WATTS BAR NUCLEAR PLANT (WBN) - UNIT 1 - NRC INSPECTION REPORT NO. 390/93-45
- REPLY TO NOTICE OF VIOLATION

WATTS BAR NUCLEAR PLANT UNIT 1
RESPONSE TO NRC'S JULY 20, 1993 LETTER TO TVA
NRC VIOLATION 390/93-45-01

Description of Violation 390/93-45-01

Support 163458
Sketch 2

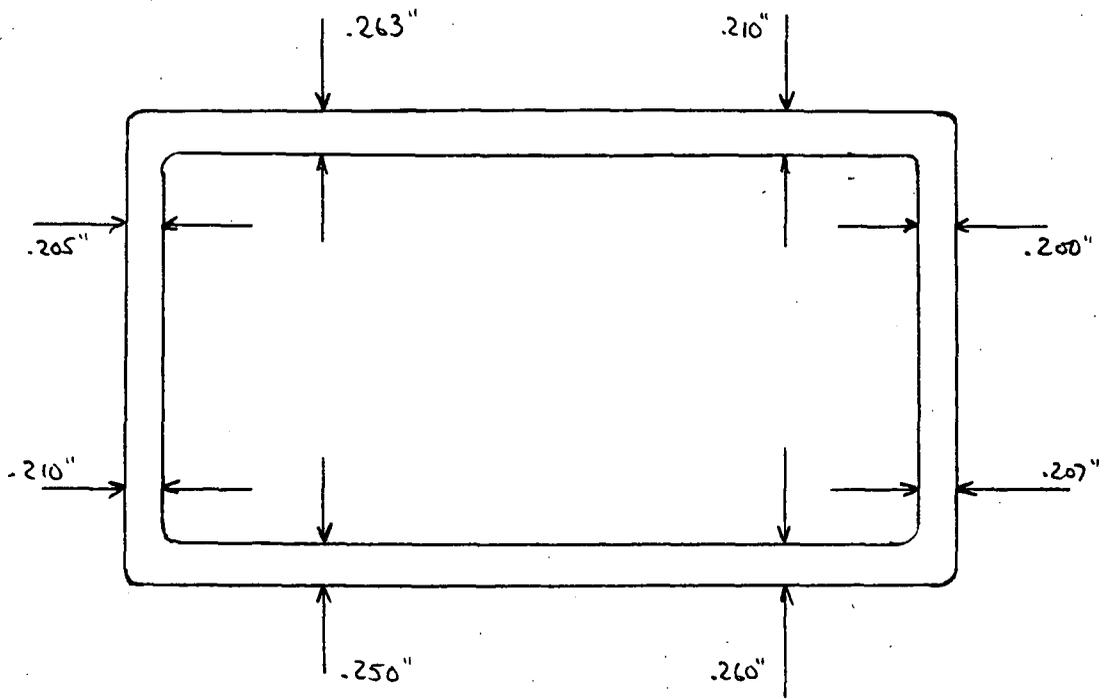
As stated in the NOV, Section 5.3.19 of the walkdown procedure WP-32 states in part, "Type, size, length, and location of welds shall be measured and either check marked as correct, corrected as required, or added to the hanger drawing or attachment." This requirement was performed for the weld on the subject pipe support.

The as-constructed drawing for the subject support indicated the weld was a 5/16" fillet weld typical (the term typical was used to mean that the weld was typical in two places, between support member 4 (Item 4) and one of the baseplates and the other weld between support member 3 (Item 3) and the other baseplate). The walkdown sketch changed the 5/16" fillet weld symbol to a near side and far side full penetration weld. The near side meaning the weld between member 4 and one baseplate while the far side meant the weld between member 3 and the other baseplate. (See attached Sketch 2).

Neither the as-constructed drawing nor the walkdown mark-up were meant to indicate that four-sided welds are required for these members, given the difficulty of implementing an inside acute angle weld.

The original pipe support calculation for support 163458 properly evaluated a three-sided weld for members 3 and 4. The walkdown data was misinterpreted during the HAAUP re-evaluation and a four-sided weld was incorrectly assumed. This misinterpretation has been evaluated and the results are inconsequential. Nevertheless, calculation 163458 was revised to address this evaluation discrepancy and DCN S-25911-A issued to reconcile the hanger drawing with the clarified weld information.

Field Measurements - Support 1074-1RHR-R1
Sketch 1

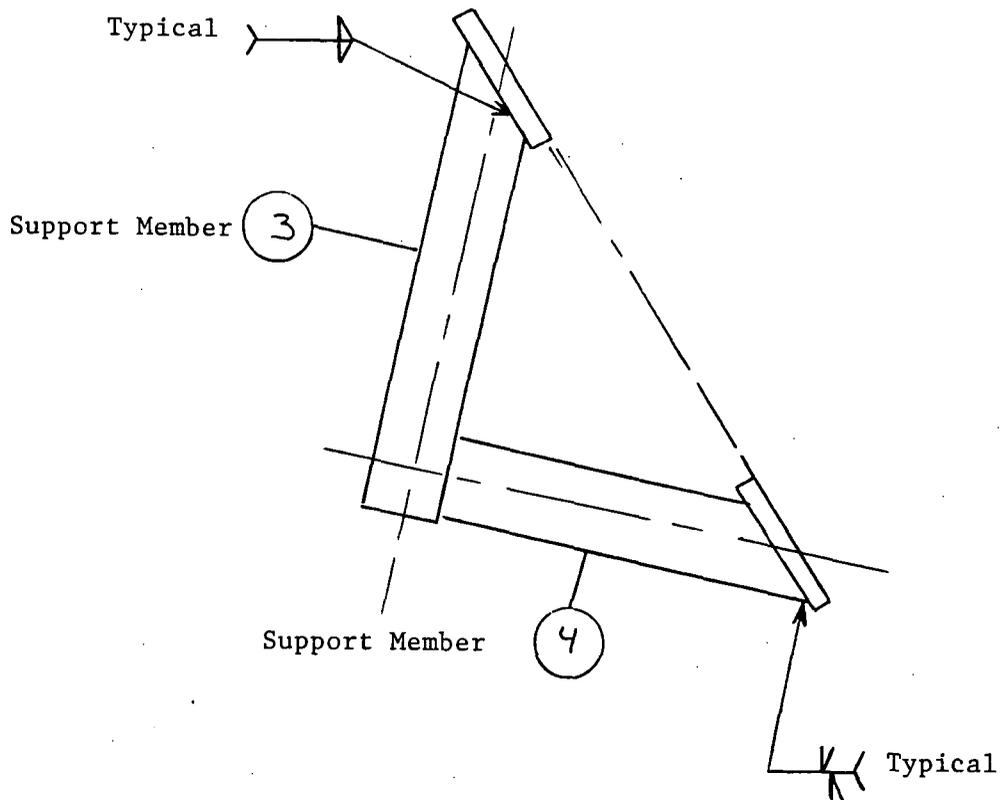
1. Paragraph 5.3.3 of procedure WP-32 requires that dimensions of the loaded length of support members shall be measured and documented. On June 21, 1993, the loaded length of a member on pipe support 1074-1RHR-R1, item 9 on the bill of material, Tube Steel 4 X 2 X 1/4 inch was not correctly measured and documented.
2. Paragraph 5.3.19 of WP-32 requires that type, size, length, and location of welds shall be measured and either check marked as correct, corrected as required, or added to the support drawing or attachment. On June 21, 1993, the type, size, and length of welds were not correctly measured, check marked, or added on the as-built drawing for pipe support 1-63-458.

Section 5.3.3 of the Walkdown Procedure, WP-32, requires lengths of support members to be measured to specific tolerances. However, for thickness of members the procedure states in part, "Nominal size of structural components (e.g., 4 X 4 tube steel, W6 member) and the thickness of closed structural members, angles, plates, and channels shall be visually verified." This requirement was performed for the subject pipe support. The walkdown sketch for hanger 1074-1RHR-R1 indicated that the member size for item 9 matched the as-constructed drawing by visual inspection.

Potential reasons for the 1/16" variation between the visual inspection and a mechanical measurement include: a) the end of the tube steel did contain burrs which apparently resulted from cutting of the material prior to installation. These burrs give the impression that the material is thicker than 3/16". b) the ASTM standard for A500 material allows a $\pm 10\%$ tolerance on tube wall thickness. The maximum allowable thickness for 3/16" material (i.e., $0.1875 + 0.01875 = 0.2063$ ") is very similar to the minimum allowable thickness for 1/4" material ($0.25 - 0.025 = 0.225$ "). Small differences such as this would not be identified by visual inspection. Actual field measurements are provided on the attached Sketch 1.

Following the mechanical verification of the actual material thickness, pipe support calculation 741RHRR001 was re-reviewed for acceptability. The minimum stress safety margin factor for this member was found to be 8.055, while the maximum deflection had a minimum margin factor of 11.51. The 1/16" discrepancy does not invalidate the structural integrity of the existing hanger.

Calculation 741RHRR001 was nevertheless revised to address this discrepancy and DCN S-25911-A issued to reconcile the hanger drawing with the revised tube thickness.
